CONSTRUCTION CHANGE ORDER 04

Block 75 Parking Ramp Maintenance Project #2689

To: SECO Construction, Inc. AEI#: 2021-504  
Contractor  
P.O. Box 2921 Contract: Prime Construction  
Rapid City, SD 57709 Date: August 16, 2023

**1. GRADE LEVEL PLAN**  
SCALE 1/4" = 1'-0"

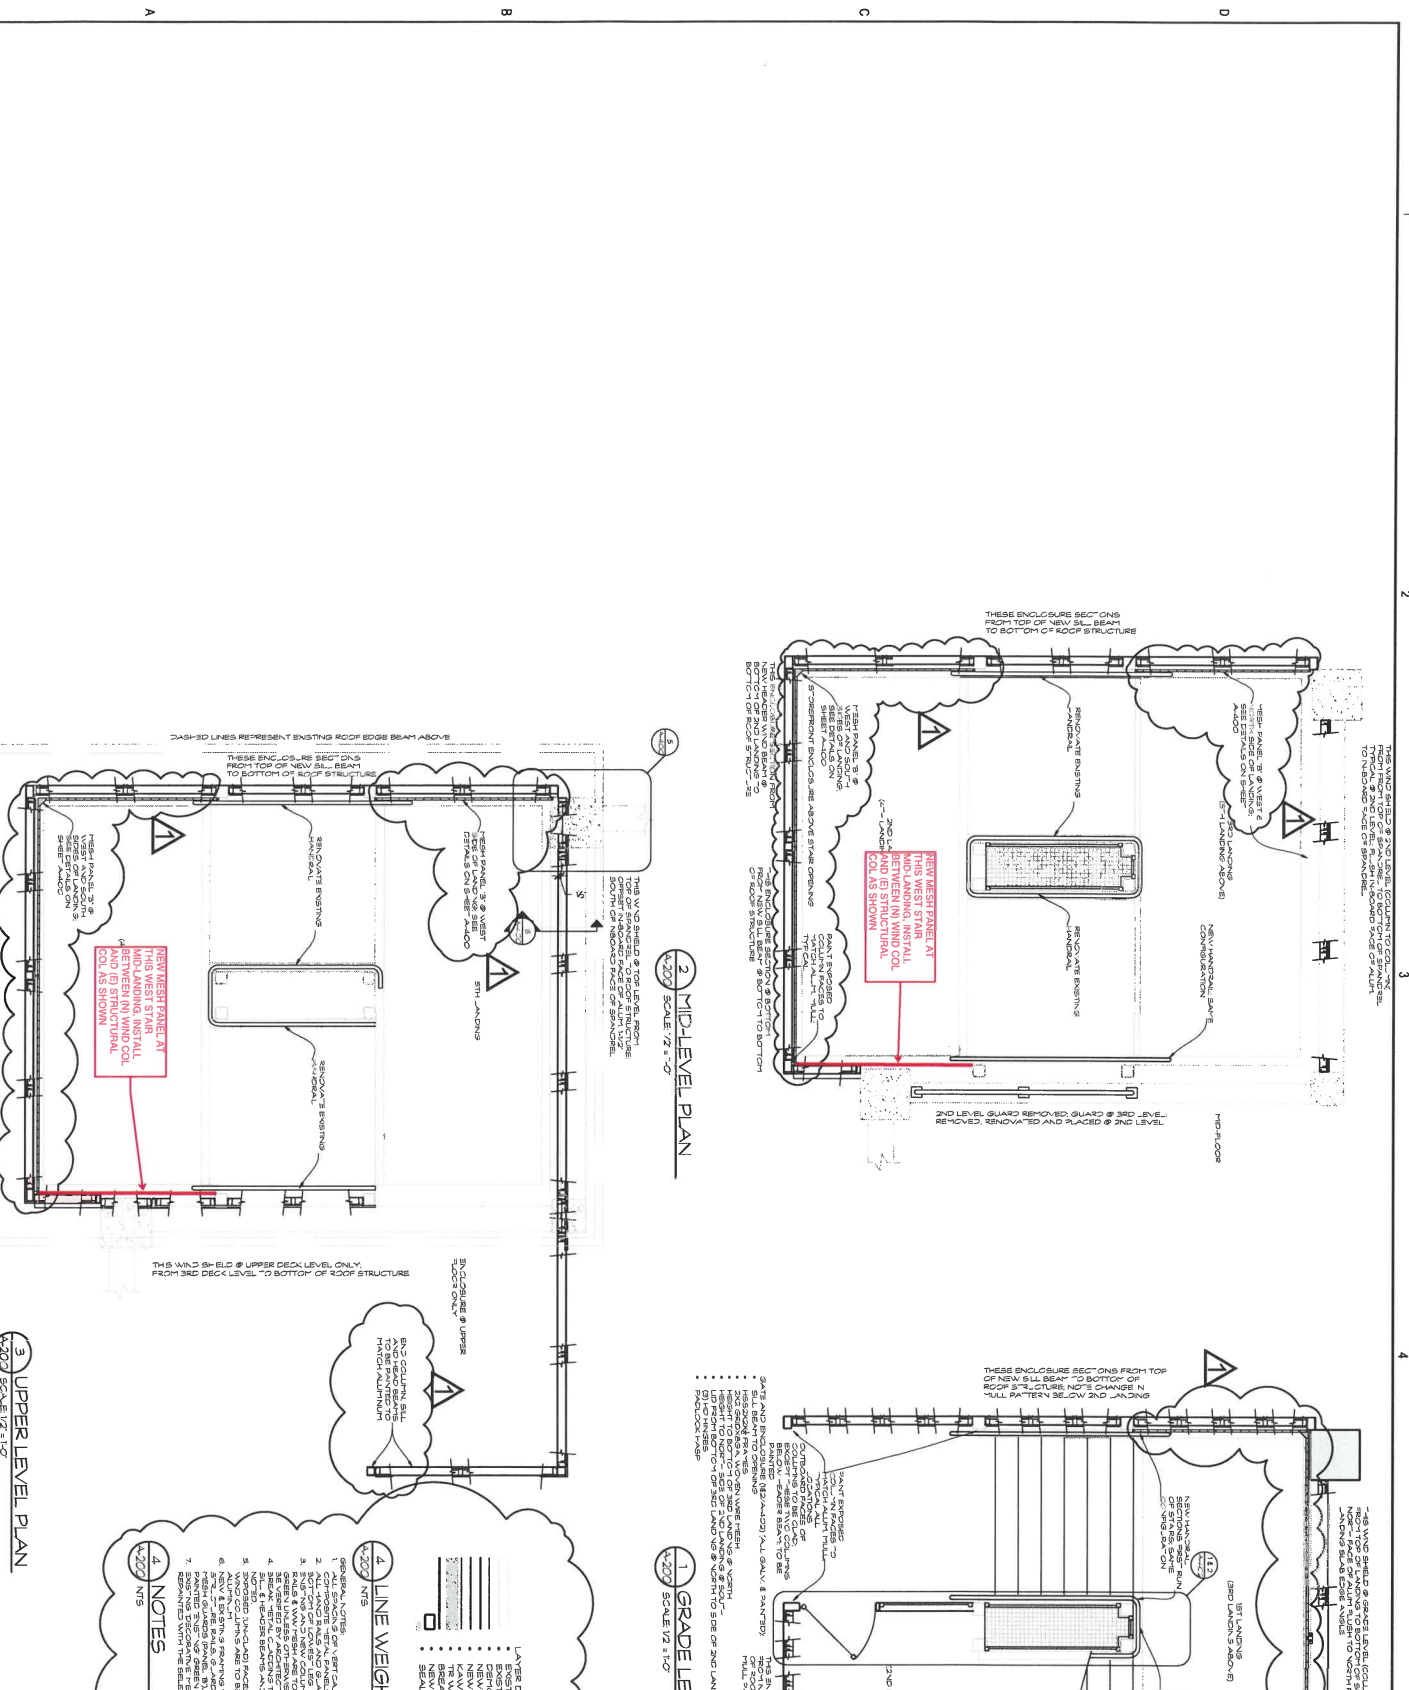
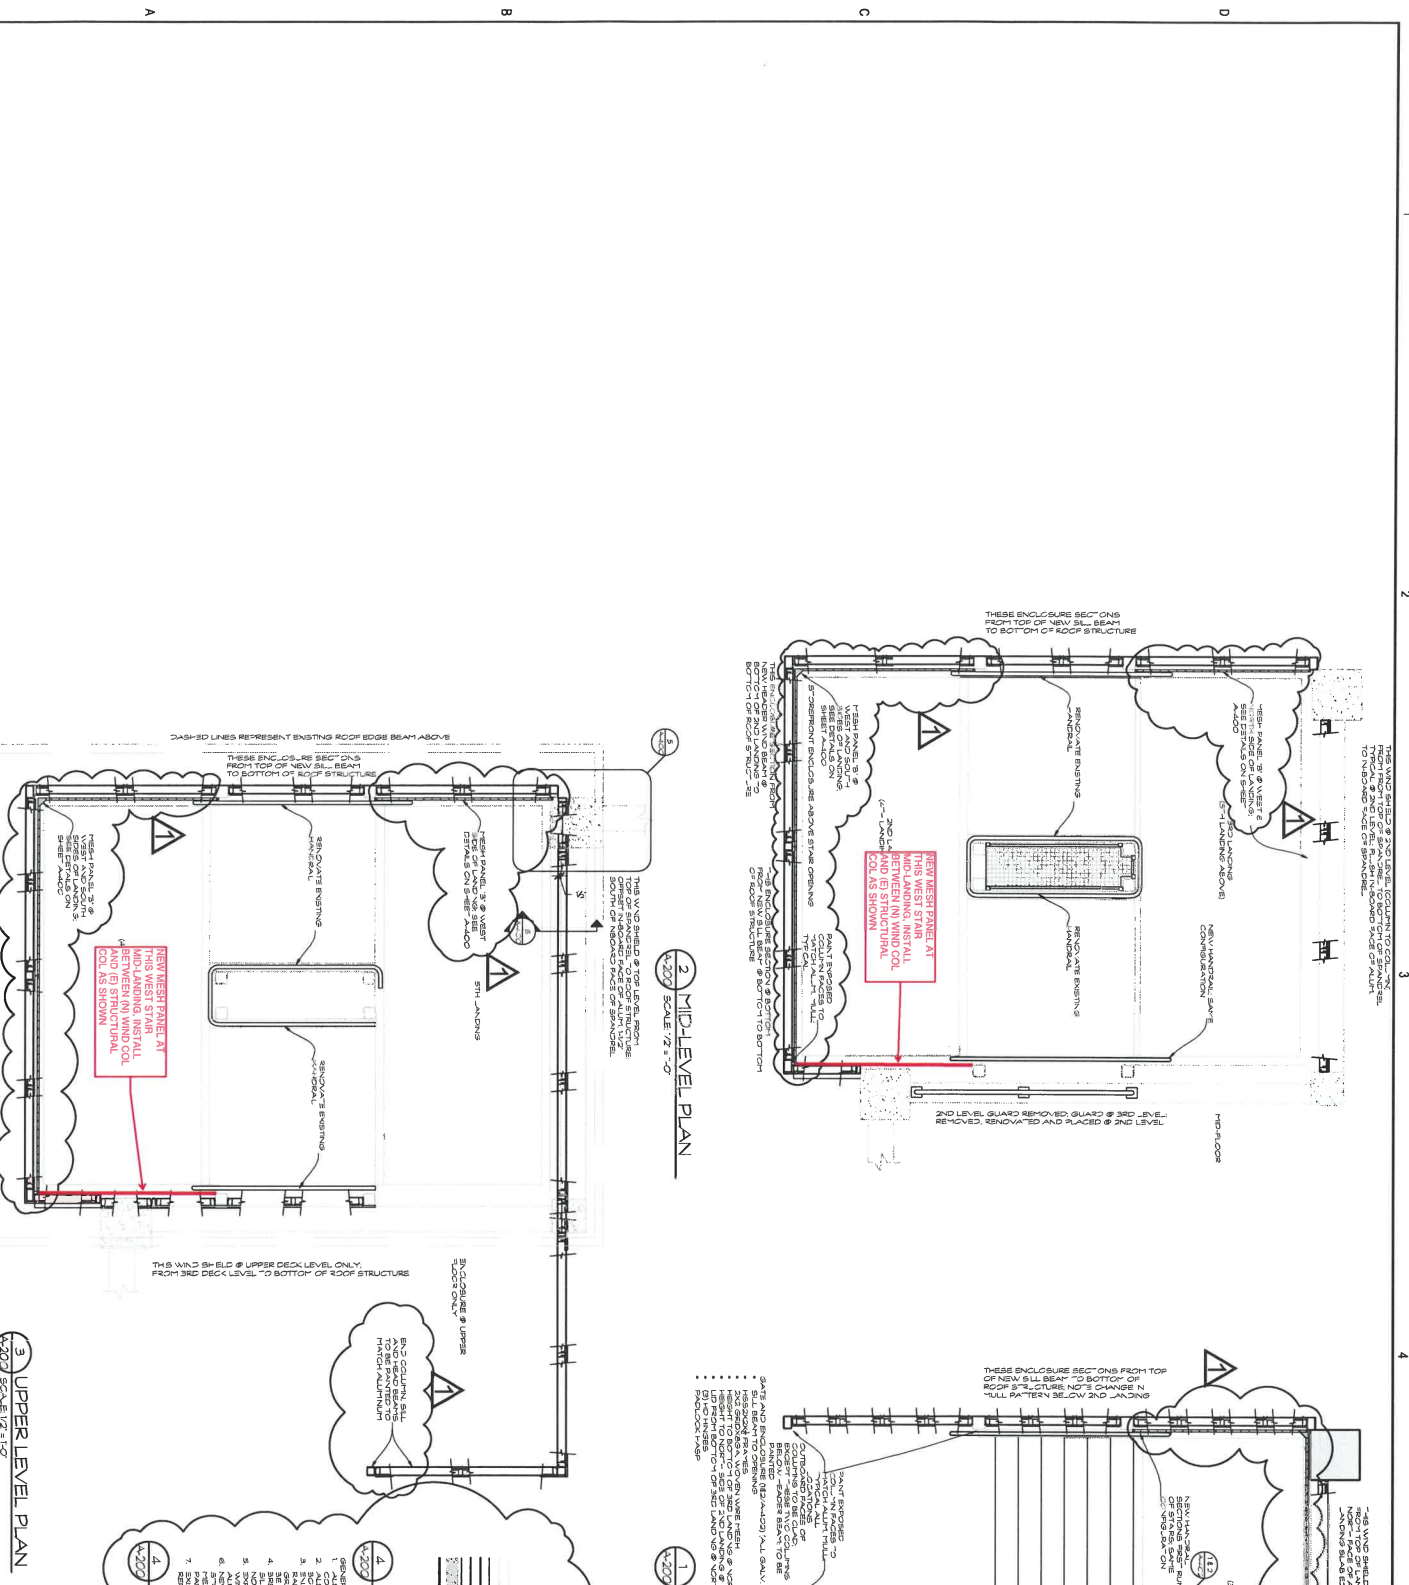
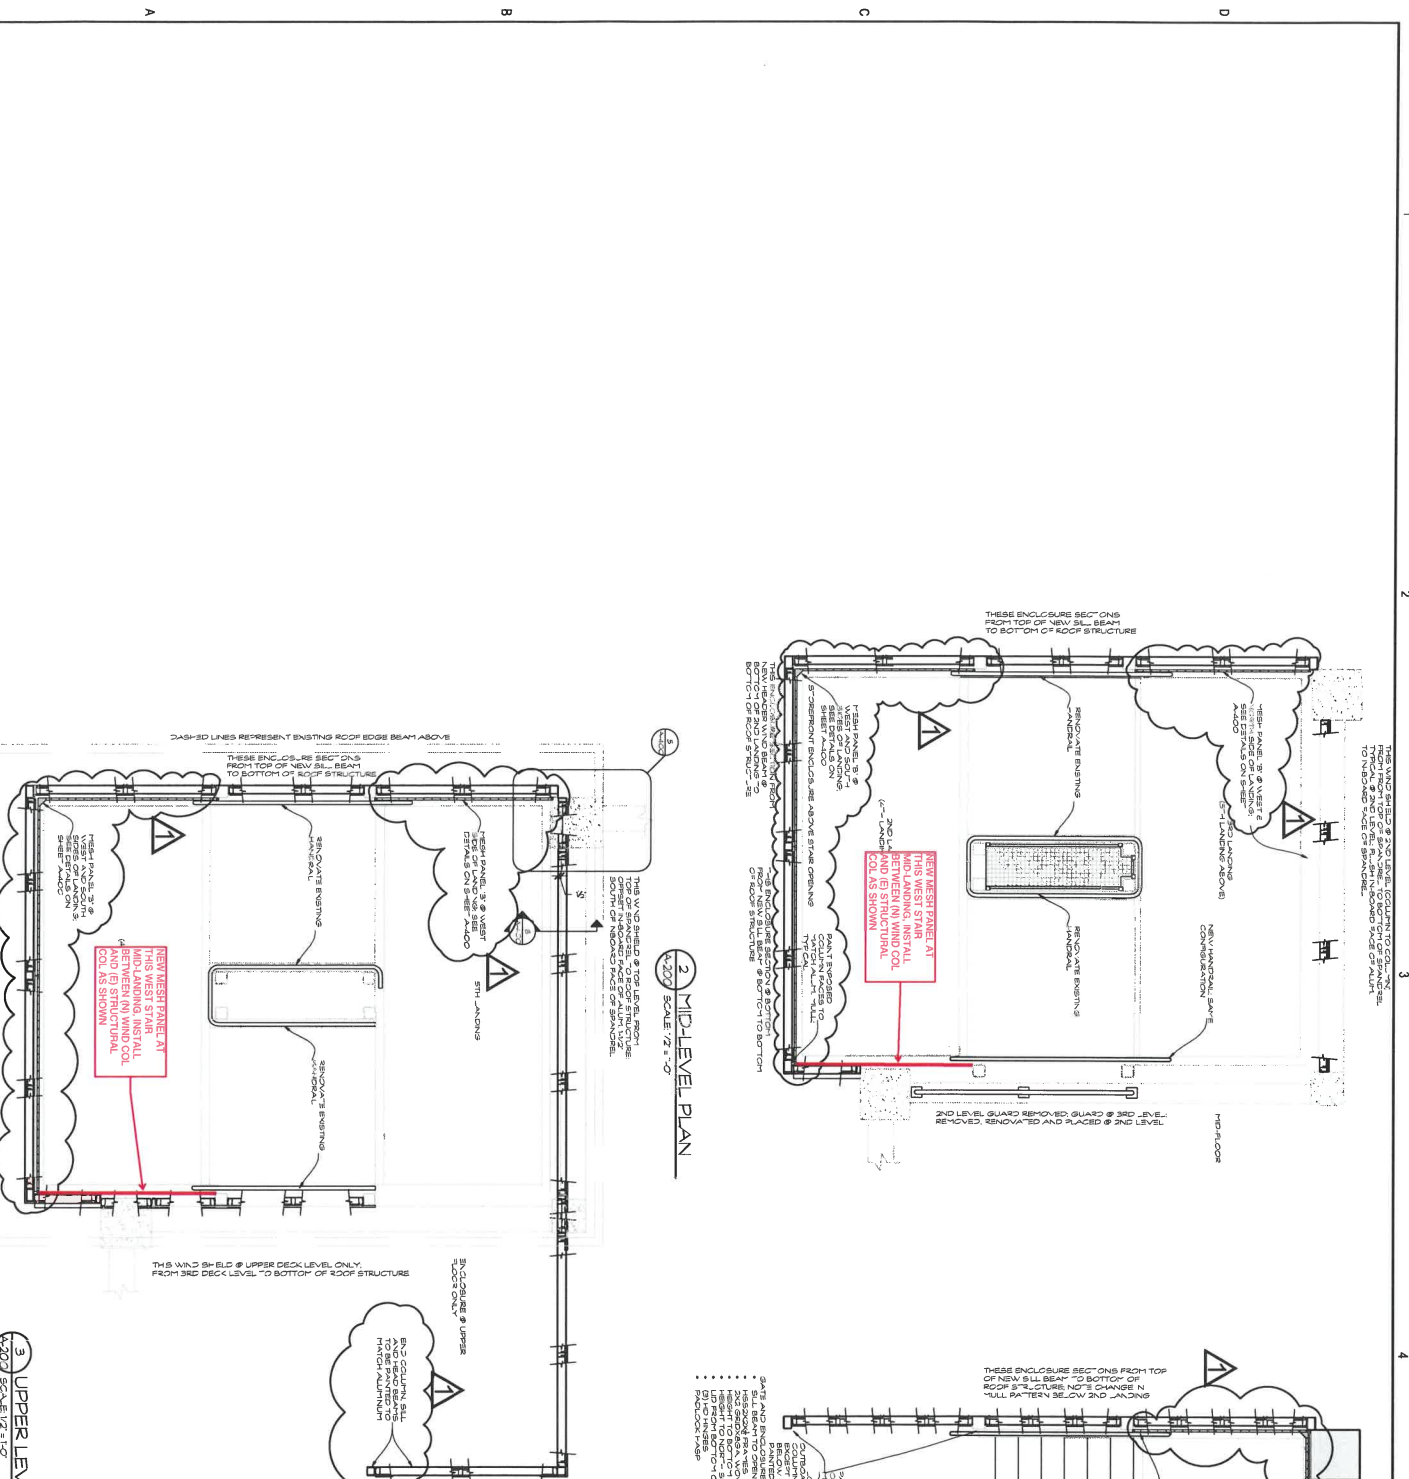
Due to existing stripping patterns on the 3<sup>rd</sup> floor adjacent to both stairways, the plan dimensions for the wind screens have to change. Attached at the end of this RFP are annotated copies of S-105 and S-106 to address the dimensions for the proposed wind screens. Please also note that at each stair only (2) bollards will be required, not (3) as originally shown in the CD's. The pricing is to include revisions associated with the structural steel modifications as well as the storefront glazing.
